On 1uH PoC Inductor

Information to 802.3dm Task Force

July 31, 2025

Ragnar Jonsson - Marvell

Noise from Power Management IC (PMIC)

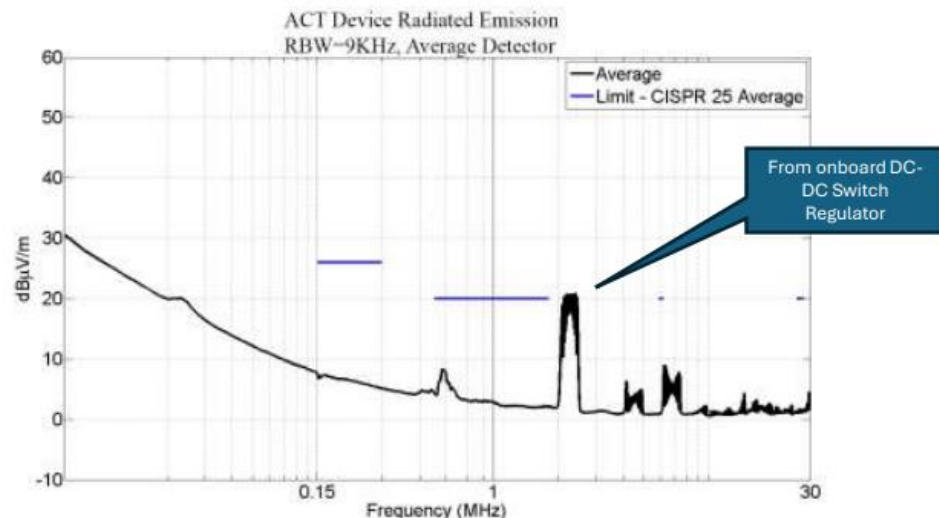
- The figure on the right is taken from the ACT EMC presentation [wu_3dm_01a_072925](https://www.ieee802.org/3/dm/public/0725/wu_3dm_01a_072925.pdf)
- The figure clearly show noise coming from the PMIC at frequency around 2MHz, which is very typical
- If nothing is done to block it, the same PMIC noise will also propagate from the PMIC back through the PoC inductor, onto the line and into the PHY
- This is a very important consideration when selecting inductors for the PoC

Return Loss for $L_{\text{poc}} = 1\mu\text{H}$

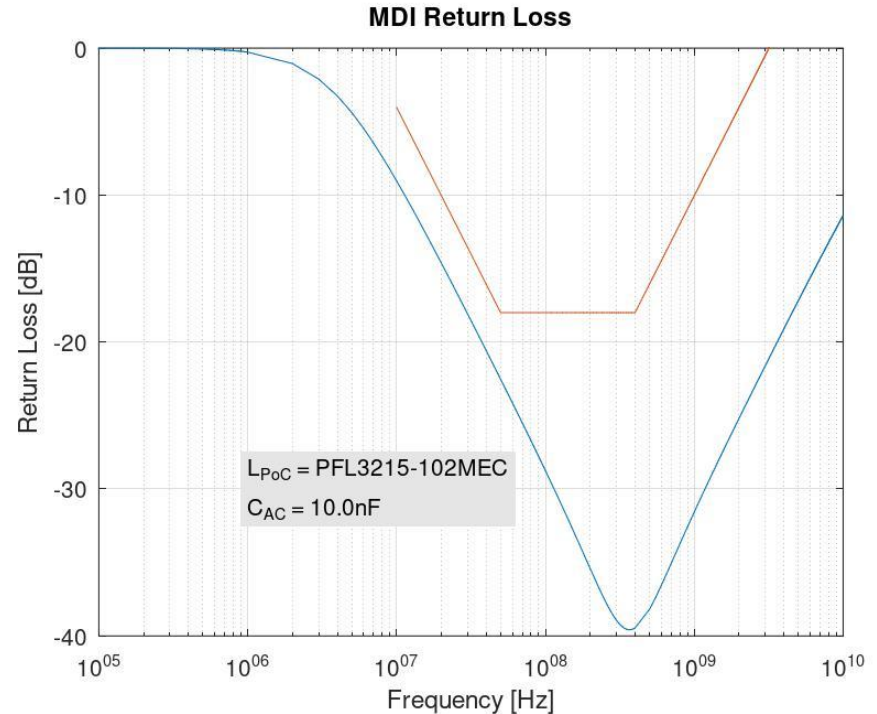
- The figure on the right shows the calculated MDI return loss for $L_{\text{poc}}=1\mu\text{H}$ and $C_{\text{ac}}=10\text{nF}$
- The MDI return loss meets the MDI RL limit defined for 802.3dm
- Does this mean that $1\mu\text{H}$ is a great inductor choose?
 - Not if we are concerned about noise from the PMIC

Blocking the PMIC Noise

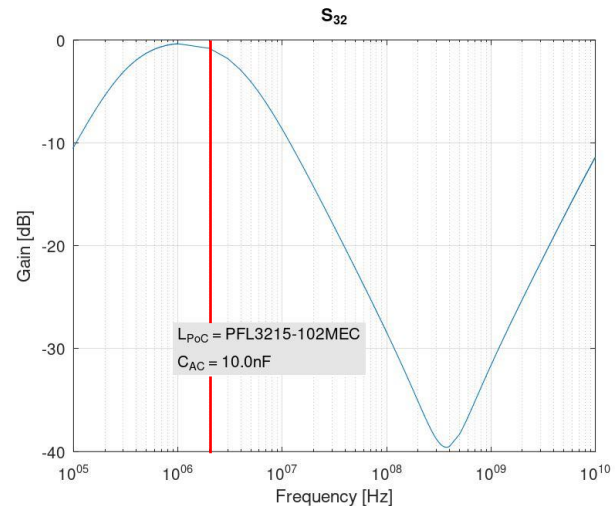
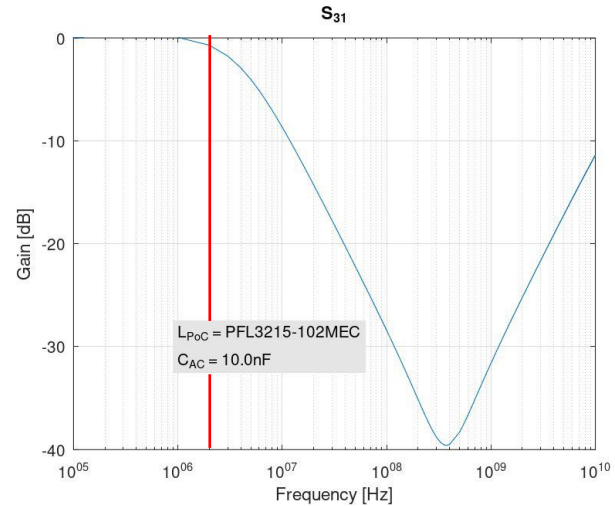
- The plots on the right show the signal transfer functions from the PMIC (Port 3) to the MDI (Port 1) and the PHY chip (Port 2), for a 1uH inductor
- Both transfer functions have almost no suppression of the 2MHz noise, so the PIMIC noise would go out on both the line and to the PHY input
- This will degrade both local and remote PHY performance unless it is filtered out by other means

Changing the AC-Coupling Capacitor

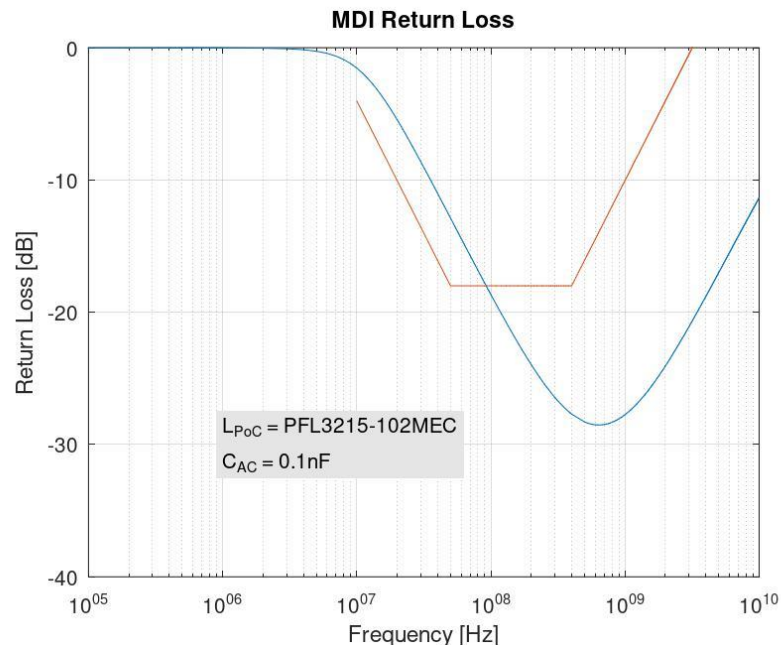
- One way to reduce the PMIC noise that goes into the local PHY is to use smaller AC-coupling capacitor
- While this can help, it will also change the MDI return loss characteristic
- The plot on the right shows the MDI RL for 1uH PoC inductor and 0.1nF AC-coupling capacitor
- This configuration clearly violates the MDI return loss requirements
